Technical News Bulletin

Steinhausen, March 2009

Plunger Up FPS with Exhaust Valve

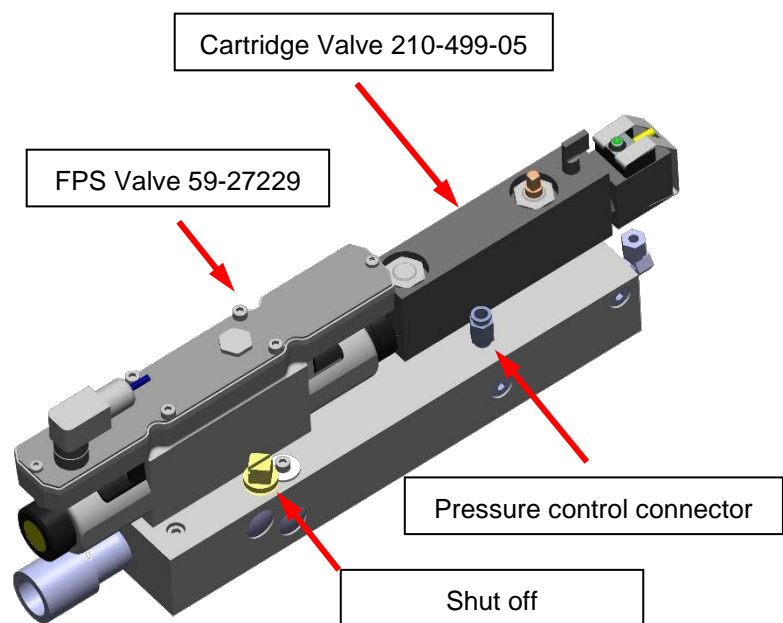
The new plunger up valve unit 200-2079-01 is based on the NIS PCM blank side design and adapted to the requirements of the IS/AIS machine. With the new setup all exhaust air is forced through a cartridge valve and not any longer through the FPS valve. This avoids potential contamination of the proportional part of the valve. The base block rests on top of the plunger up manifold. The aluminum block carries the ED07 plunger up FPS valve (59-27229) and a normally closed (NC) cartridge valve. The cartridge valve is placed in the standard Emhart Glass block, with a manual override and a needle control for the exhaust air.

The user friendliness of the unit has also been improved. All adjustments and handling can be done with access

from the top of the valve block. The air supply to the block is direct from the manifold. The exhaust is partially going into the exhaust manifold and partially into the atmosphere. The needle on the exhaust valve controls the exhaust air coming back from the plunger up line. The cartridge valve is identical to the NC valves used in the 26 line Valve Block, on the Universal Conveyor Valve Block and on the NIS PCM blank side.

The shut off cuts the supply air to the FPS valve, which allow changing the FPS valve in MS. To change the cartridge exhaust valve the section needs to be in MS and the pilot air supply needs to be shut off. The top accessible pressure control connector provides the possibility to read the actual pressure in the working line by connecting a manometer.

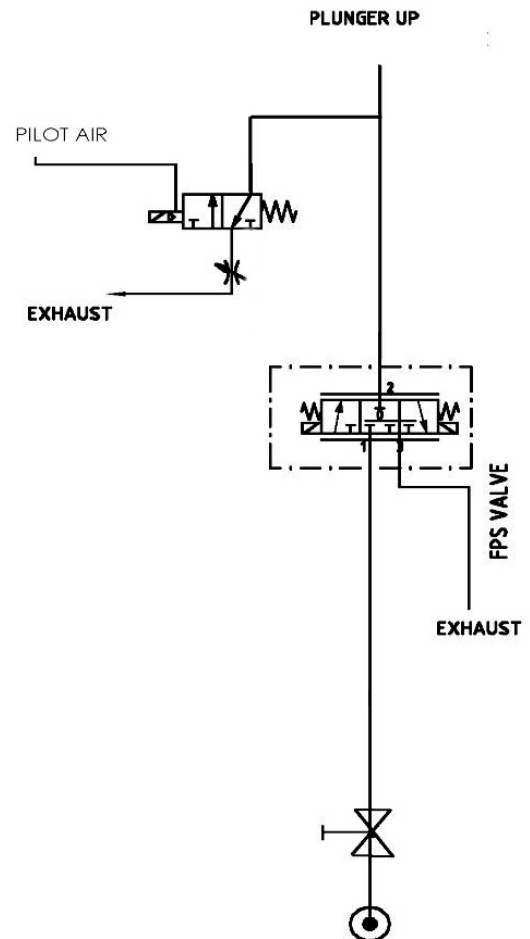
The operation of new valve unit combines the features of the two types of valves used. The FPS valve is used to create the pressure as it is required by the process. The exhaust valve is less sensitive against dirt and all exhaust air, but not the exhaust air which is required for the pressure control, will go through the NC cartridge valve. This allows for a quick exhaust with the sensitivity on the needle control build into the cartridge valve. A good needle control on the plunger up exhaust air is important to control the impact on plunger down especially in NNPB process. With this valve setup the speed and precision of the plunger movement to the loading position in NNPB and from the up position to the counter blow position in BB is significantly improved. With the FlexIS control system and the recently introduced possibility for Mixed Event Assignments the entire valve block with both valves can be timed with only one event. This allows the operator to work with the plunger up event in the same way as before.

To avoid the contamination of the FPS valve with the dirt, particles, residues of swabbing and lubrication the main exhaust air flows through the cartridge valve. This is ensured by the software function of the FPS valve. At a pressure set point on 0bar ($\leq 4\text{mA}$) the FPS is closing both the supply and the exhaust port forcing all the air through the exhaust valve. In MS (maintenance stop) condition the normally closed cartridge valve (NC) is exhausting the working line for plunger up. In most cases the plunger down valve is normally open (NO) valve to force the plunger down in MS. This means the plunger up exhaust valve is able to exhaust the leakage air which is flowing into the plunger up cylinder from the plunger down pressure and avoids the creeping up of the plunger while all valves de-powered.
